COMPREHENSIVE GROUND WATER MONITORING EVALUATION
OF THE
SOUTHERN CALIFORNIA CHEMICAL COMPANY

EPA ID NO. CAD008488025

3 June 1988
(revised 15 June 1988)

Comprehensive Ground Water Monitoring Evaluation
FY 87-88

Figure 3. Ground Water Elevation Map

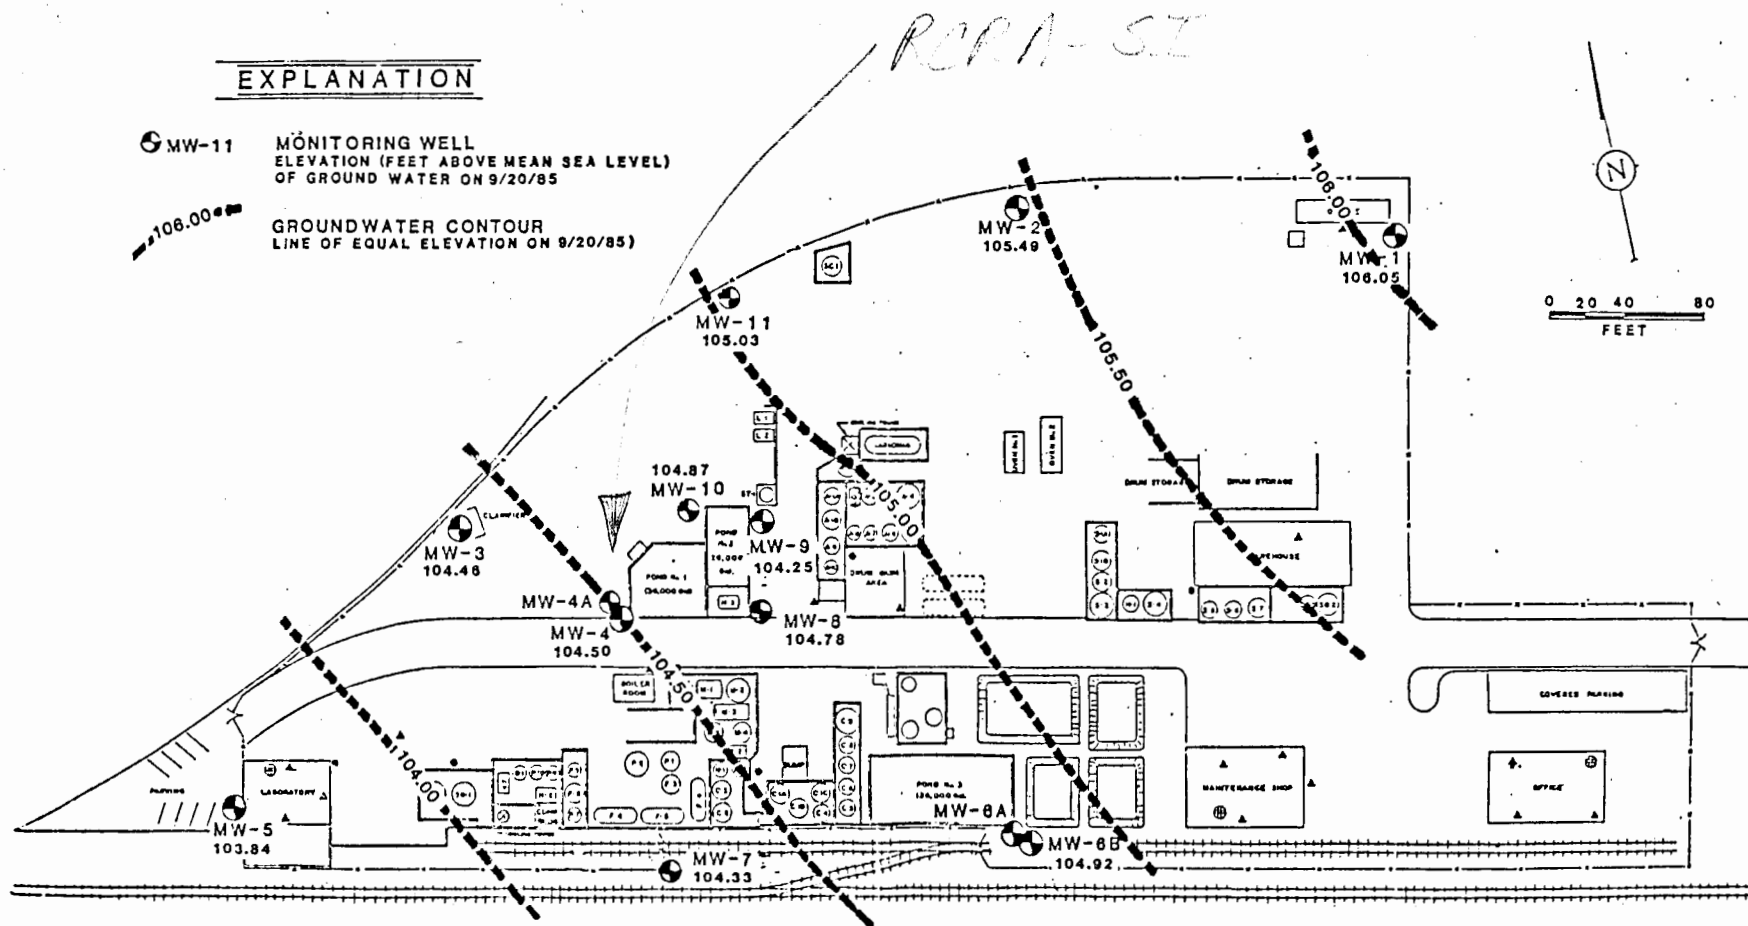
The regional ground water gradient in both the Gage and Hollydale Aquifers is to the southwest. Figure 3 is the most recent ground water elevation map prepared by J. H. Kleinfelder & Associates

Figure 6

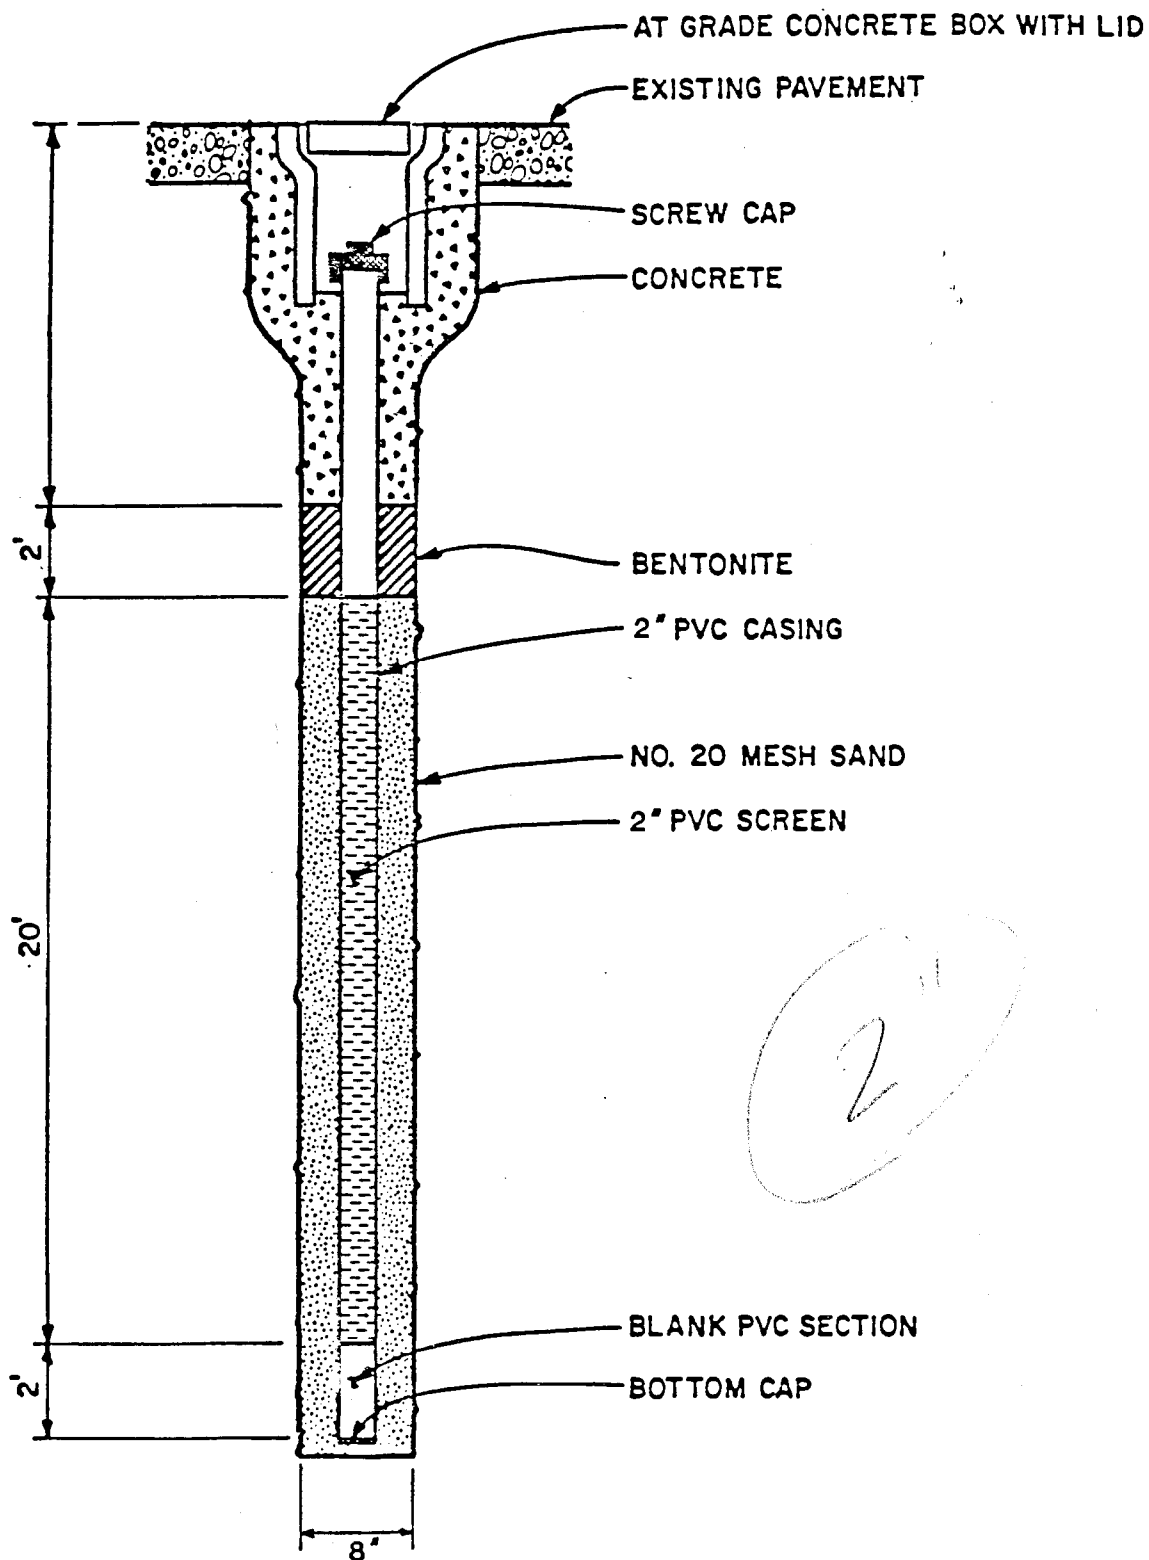
J. H. Kleinfelder & Associates has submitted several different "well configuration" diagrams as examples of how monitoring wells are constructed by the company. Of the 13 ground water monitoring wells, 11 are 2-inch diameter wells (Figure 6) and two are 4-inch diameter wells (Figure 7). However, the original drill logs indicate that none of the wells were constructed according to the "typical" well construction diagram, as explained below:

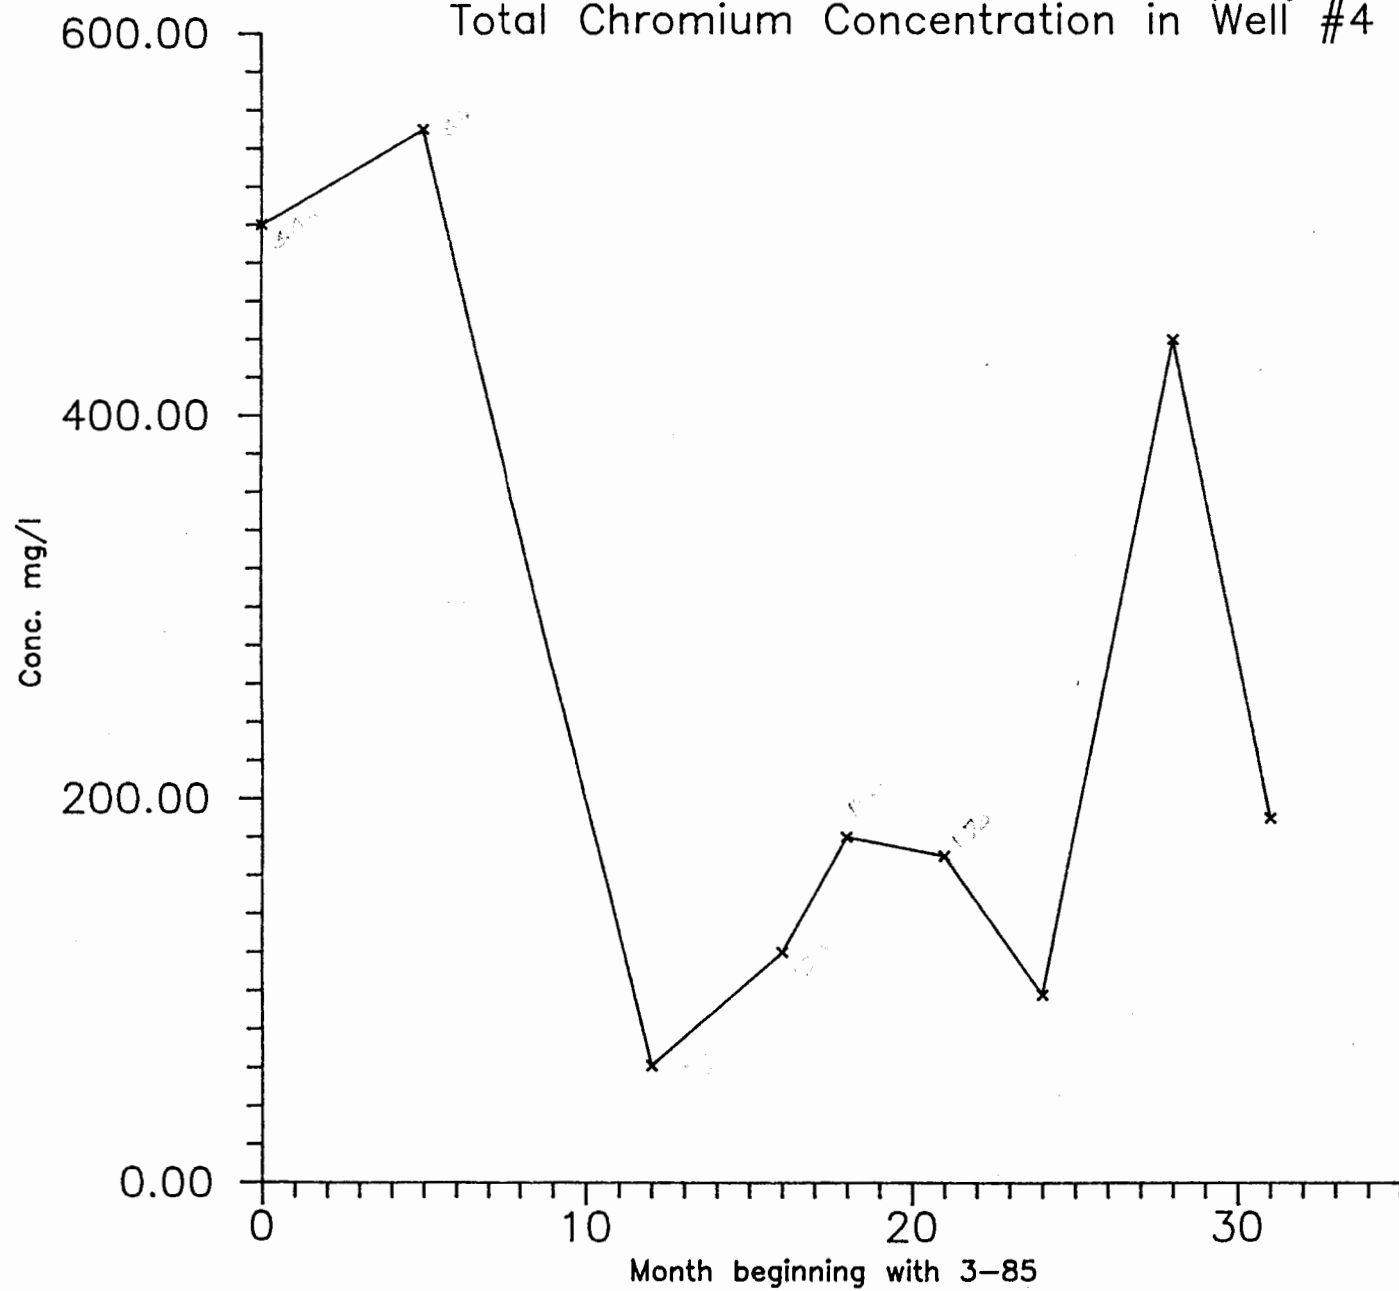
Elevated levels of hexavalent chromium have been detected in MW-4 and MW-9. In MW-4, chromium was originally detected at 500 mg/L; since that time (March 1985), the levels have fluctuated between 61 mg/L and 550 mg/L. The most recent analysis (October 1987) detected 190 mg/L. Figure 8 shows how the chromium contamination in MW-4 has changed with time. Figure 9 shows the fluctuations in water levels beneath the facility. A comparison of these seems to indicate that the concentration fluctuates with the ground water levels.
